CHANGE ORDER REQUEST FORM

PROJECT William Burgess Extension

No. 005

Plan Revision No. 02 reconfigured the drainage system leading into Pond D. The revision redirects water directly from structures S-75, S-76, S-78, S-80, and S-81 to the MES within the pond. This change eliminated a deep pipe run and resulted in cost savings for the County

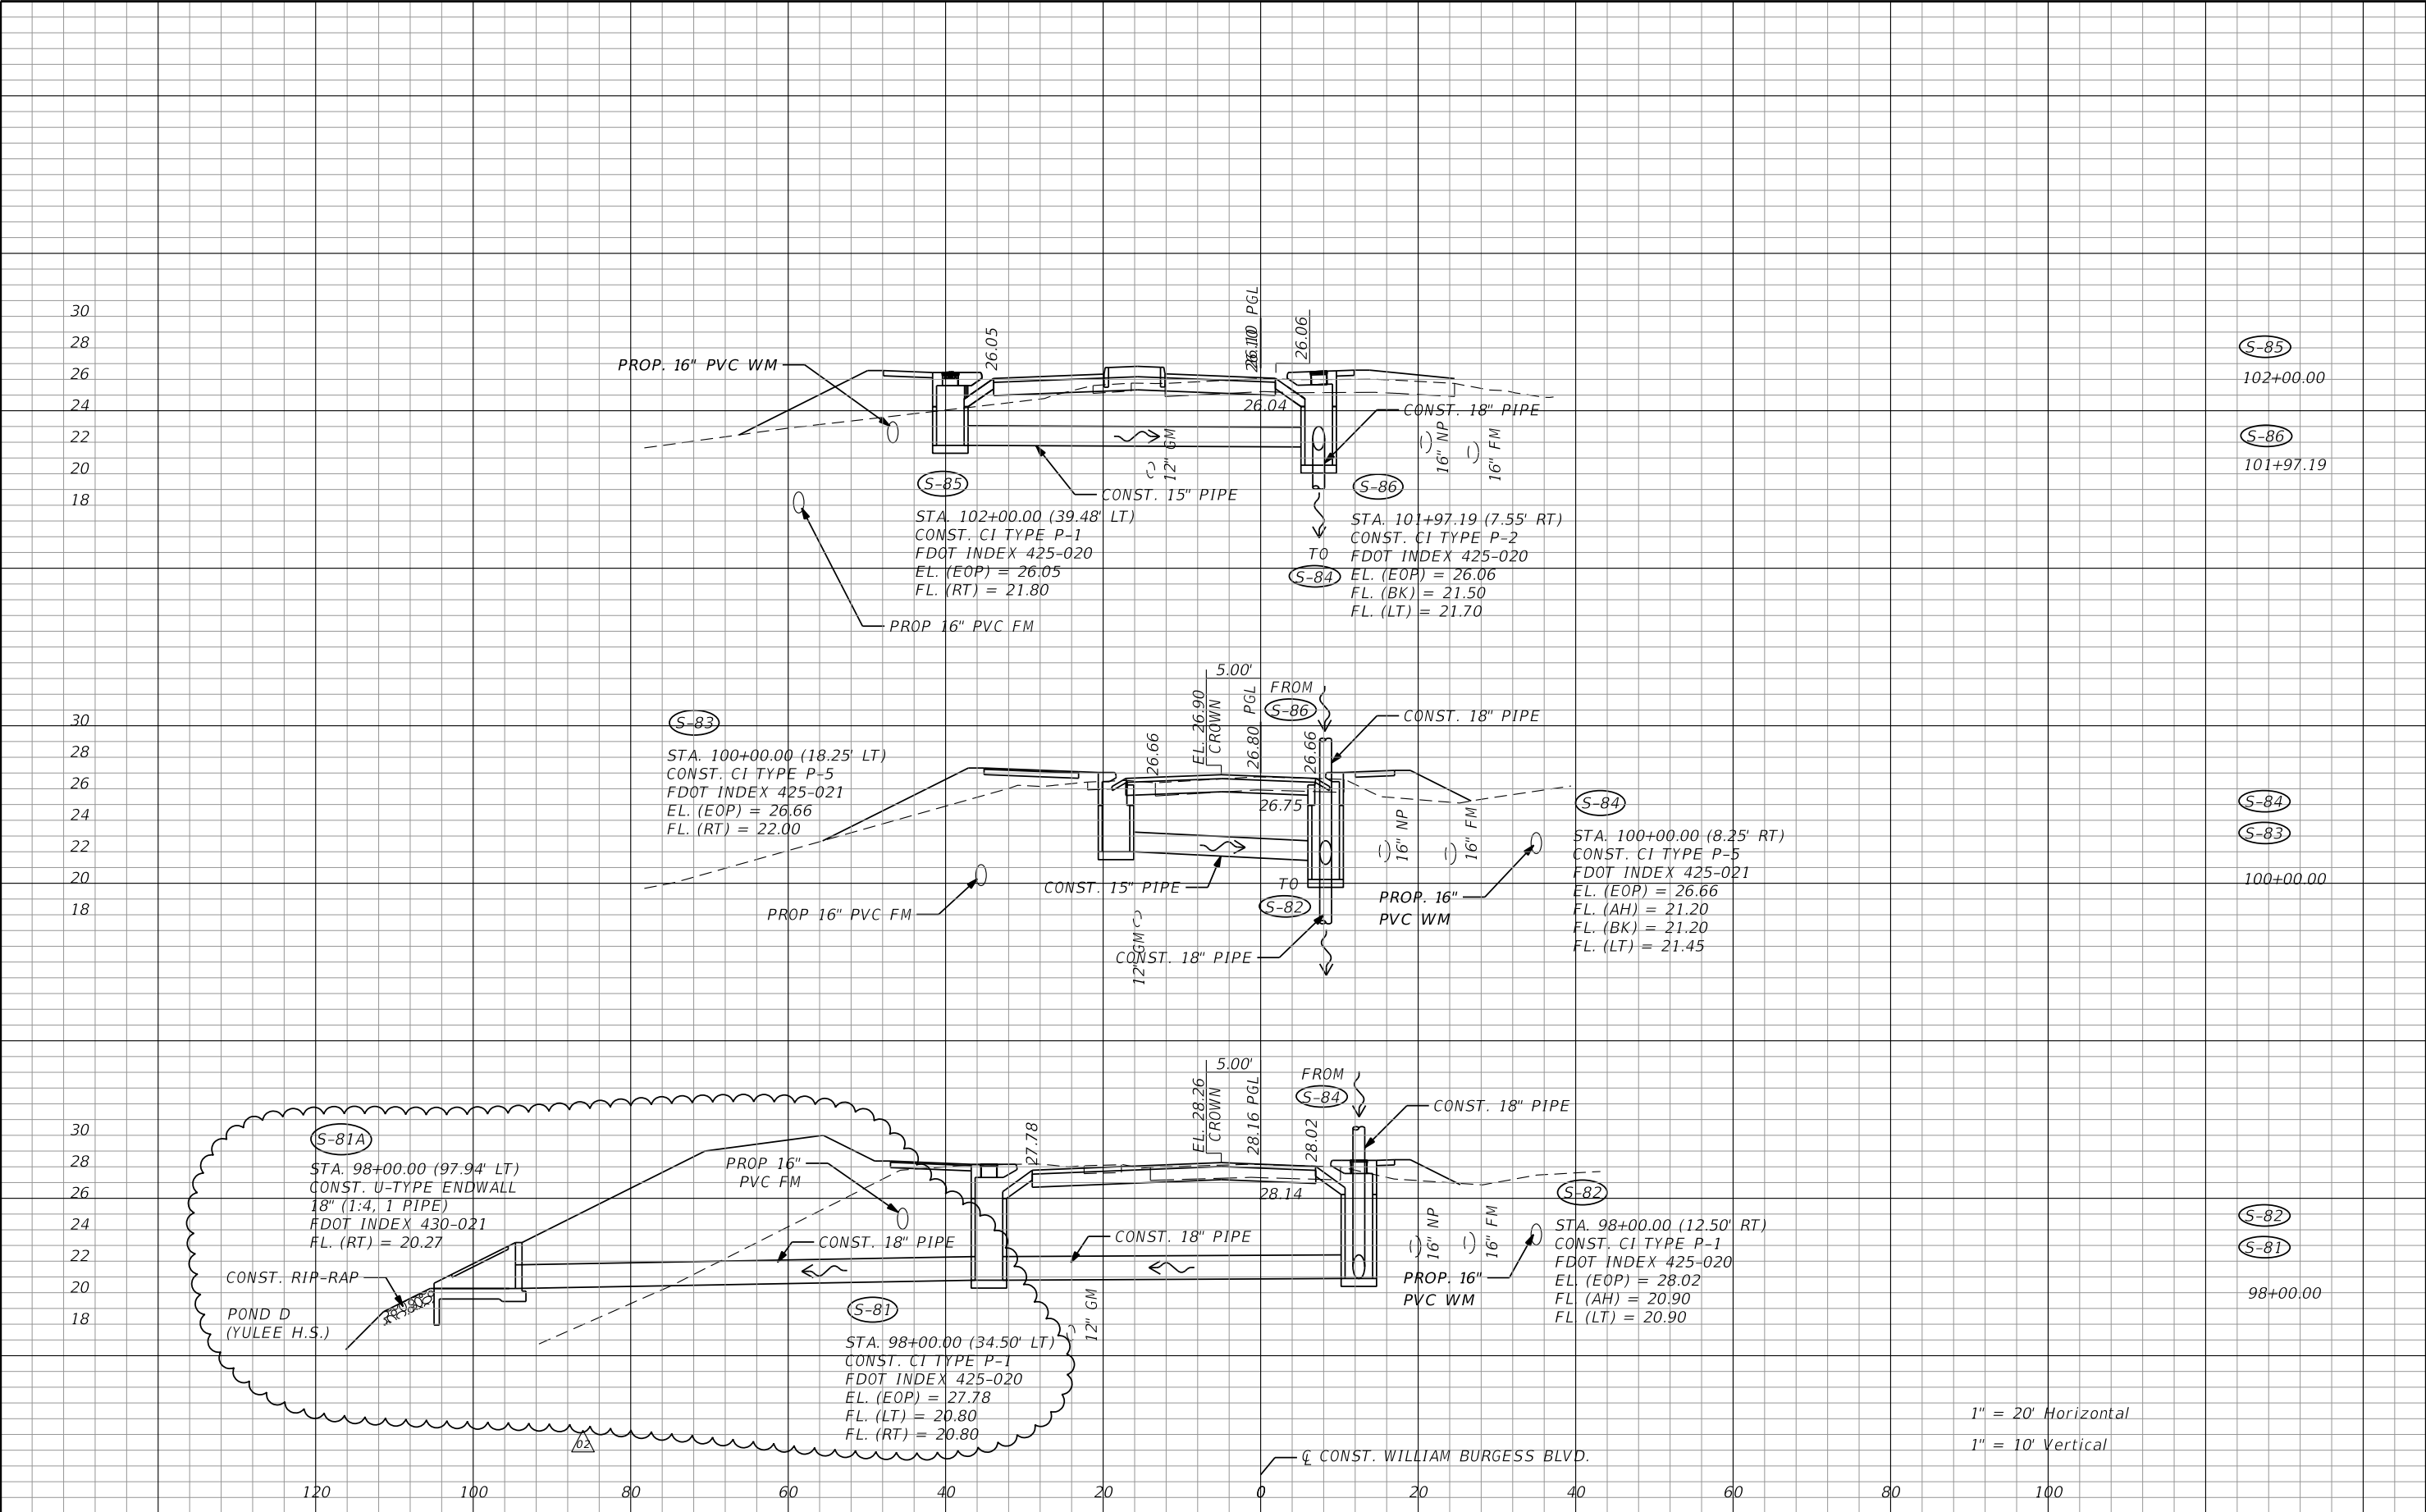
REVISIONS			
REV	DATE	BY	DESCRIPTION
02	1/13/25	RFH	STORM SEWER ADJUSTMENT

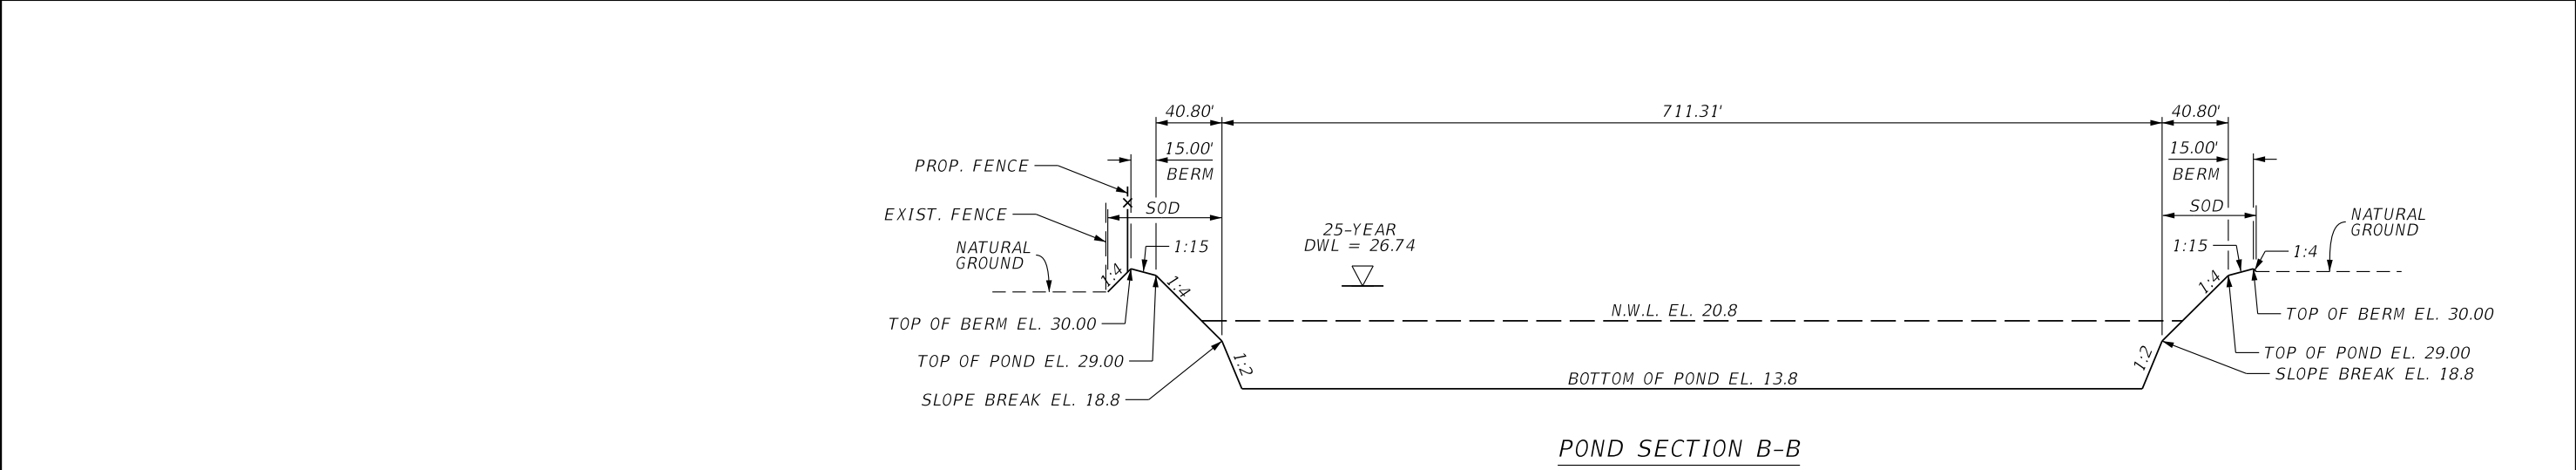
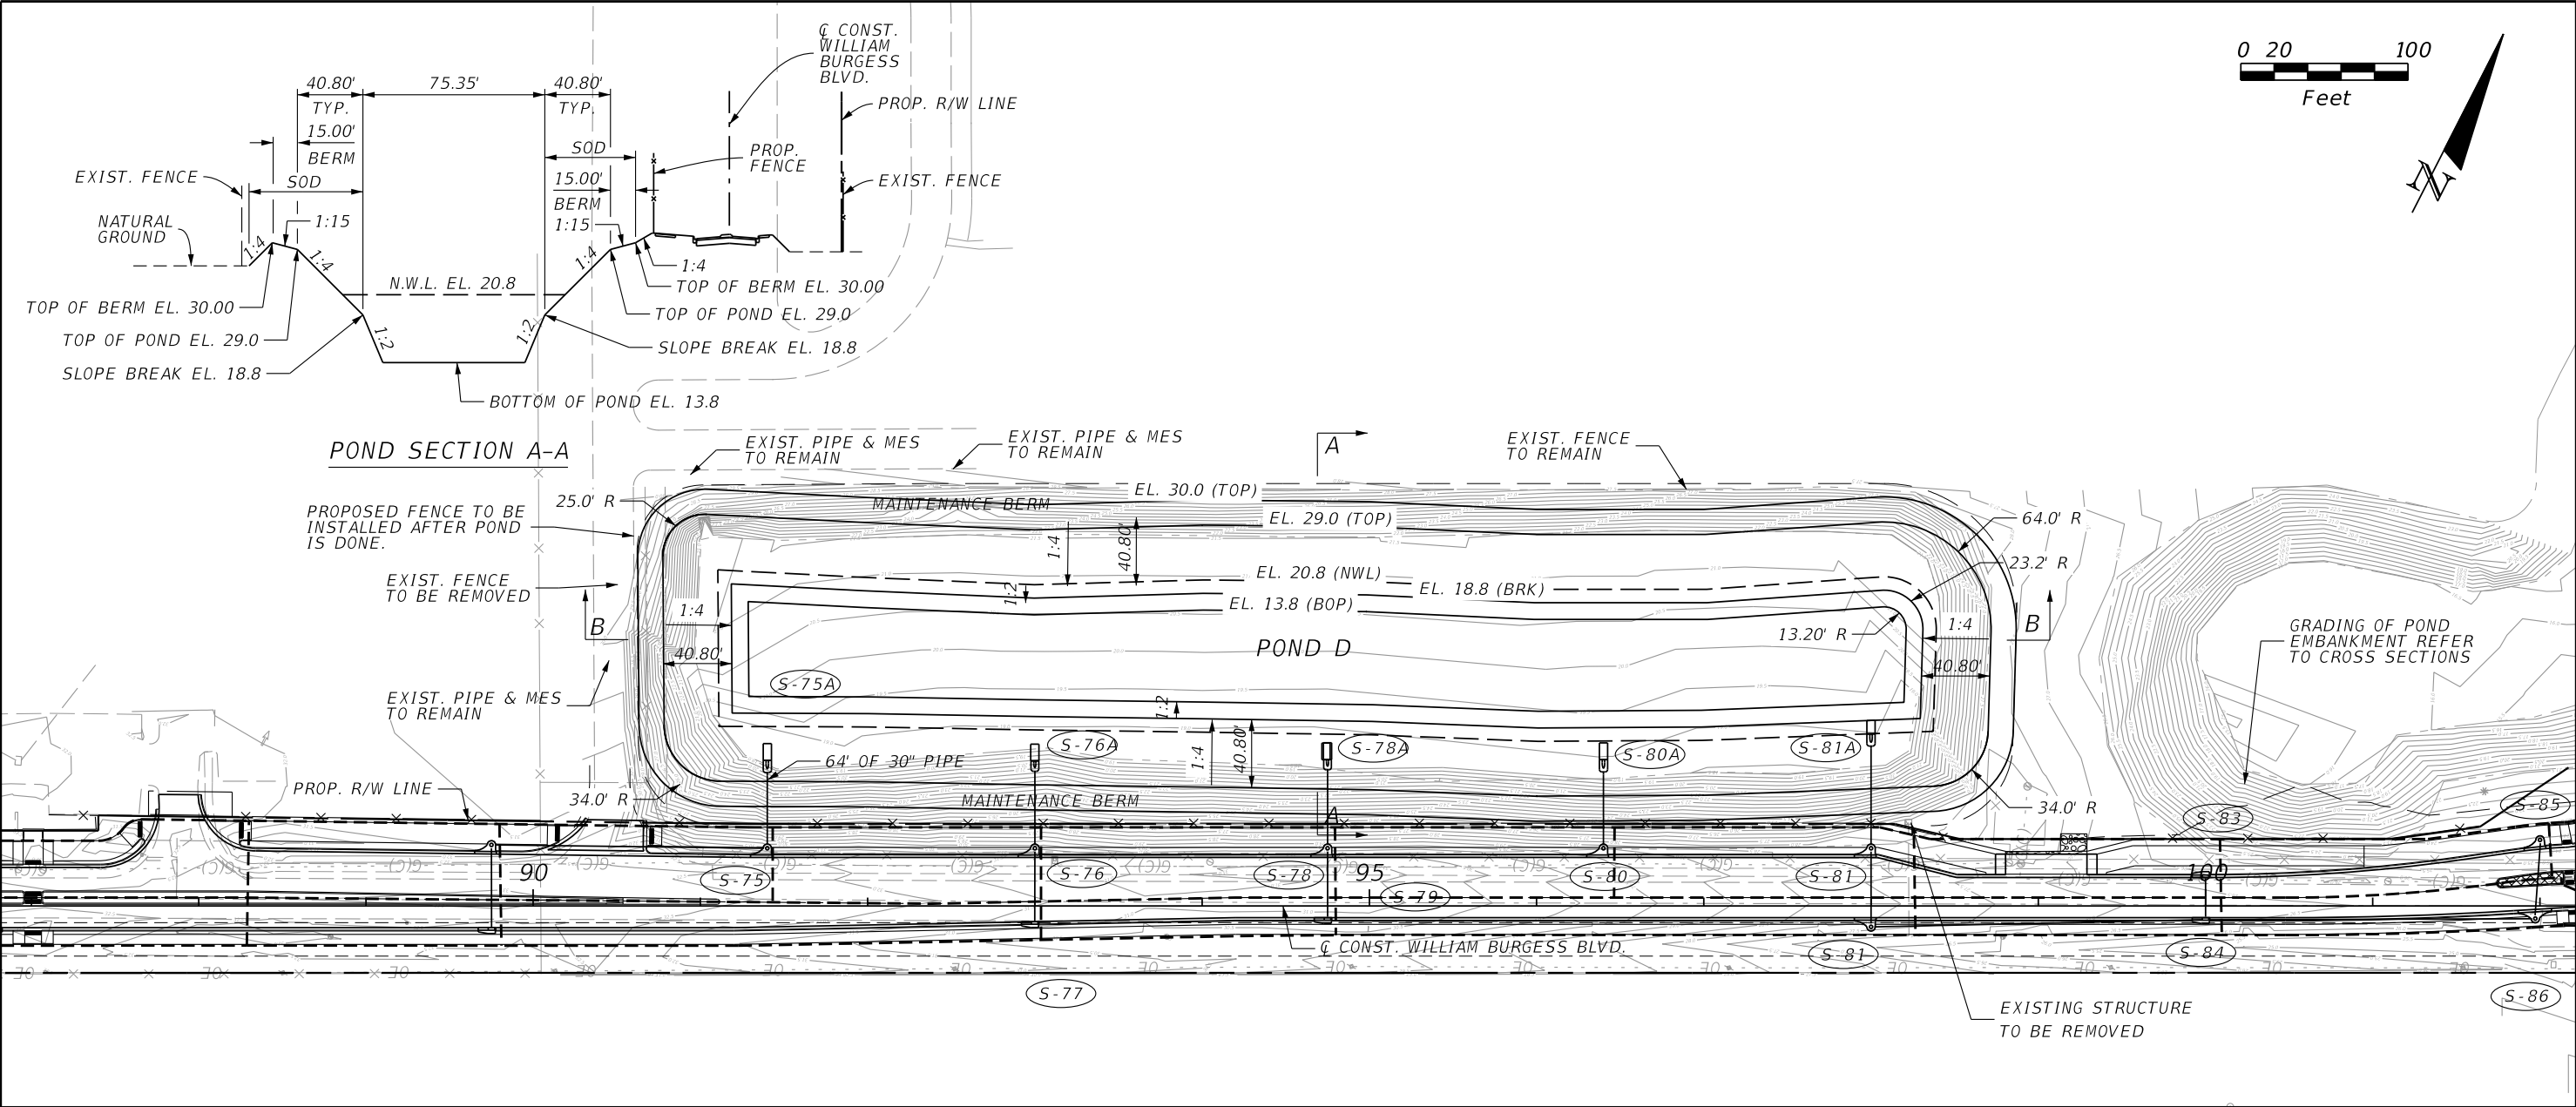
Reason for Change Order:
Plan Revision No. 02 reconfigured the drainage system leading into Pond D. The revision redirects water directly from structures S-75, S-76, S-78, S-80, and S-81 to the MES within the pond. This change eliminated a deep pipe run and resulted in cost savings for the County
